FOR PERMITTING ONLY
4/2/04

CIAMPI RESIDENCE REMODEL
PORTLAND MAINE

DRAWING TITLE: SCHEMATIC PLANS AND ELEVATIONS
SC.1

SCHEMATIC SITE PLAN
(SEE SURVEY FOR DETAILS)
1/8" = 20'-0"

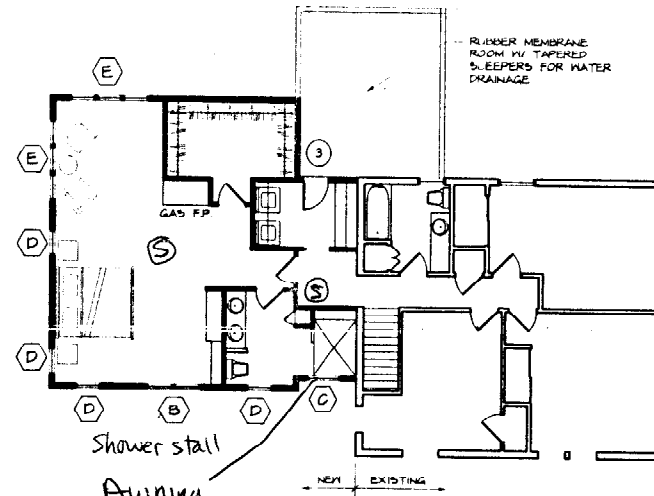
R3 Zone

Front 25' Req 32'-7" Shown

Rear 25' Req 52'-2" Shown

Side 2 story 14' Req 14' Shown

Existing 16x20 deck 8' req 10' shown

PROPOSED 1ST FLOOR PLAN
1/8" = 1'-0"

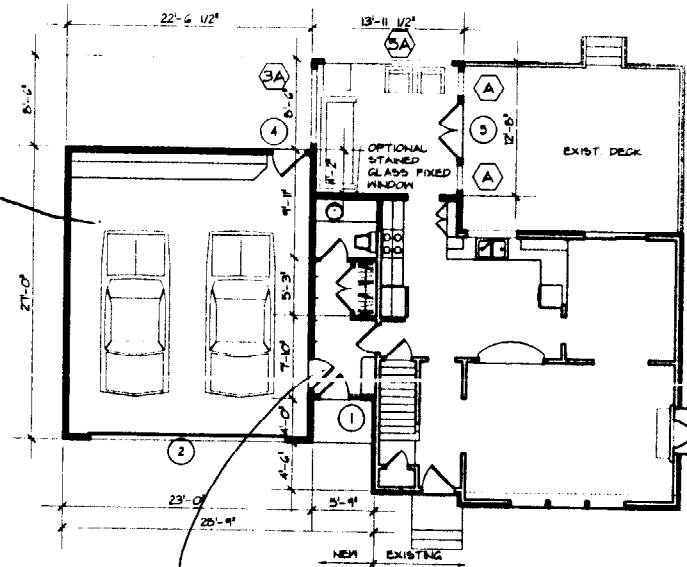
5/8" typ x G.W.B.
all walls & ceiling
Taped

PROPOSED RIGHT ELEVATION
1/8" = 1'-0"

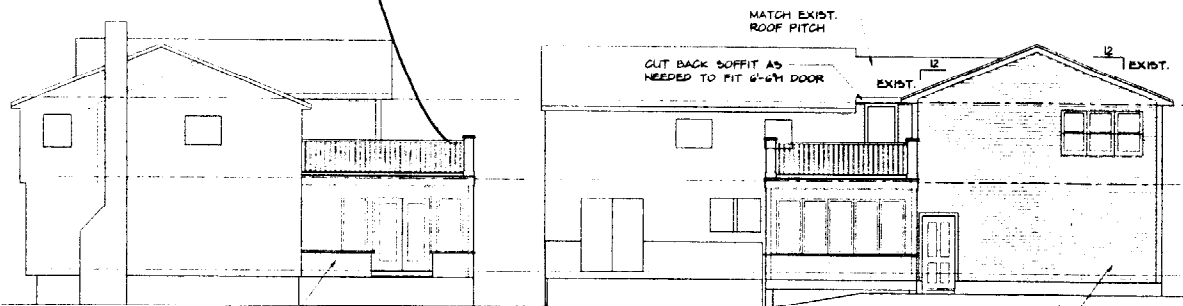
36" min height
4" space betw/ balusters
